RE: Geotechnical Addendum Letter
Tigert Middle School Additions
250 East 2nd South
Soda Springs Idaho

STRATA, Inc. (STRATA), has prepared this letter as an addendum to the originally issued geotechnical engineering evaluation dated October 9, 2017 for the Tigert Middle School Additions to be located at 250 East 2nd South, Soda Springs, Idaho. The intent of this addendum letter is to revise select recommendations, based on documentation that was provided by you on October 24th, 2017.

EXPLORATION LOCATION PLAN
Tigert Middle School Additions
Addendum Letter
Soda Springs, Idaho

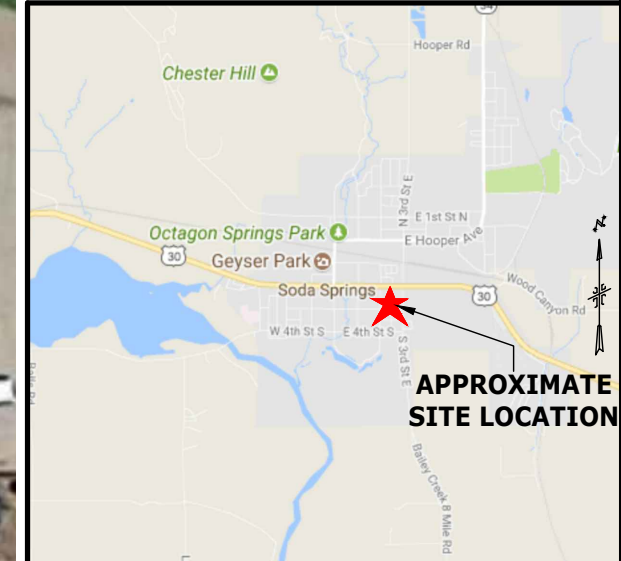
Based on this information, a significant portion of soil at the site, previously considered undocumented fill, should now be considered documented fill. We provide a revised Exploration Location Plan indicating the locations which we now consider to be documented fill.

Only one location (B03) was identified to include documented fill based on our exploration program. Undocumented fill was identified in the other gymnasium exploration locations, and as such, our recommendations regarding undocumented fill is not changed by this addendum. We provide a revised Exploration Location Plan indicating the locations of undocumented vs documented fill. STRATA should observe excavations in order to assist in identifying transitions between documented and undocumented fill. Site preparations or clay subgrades within the original report remain unchanged.
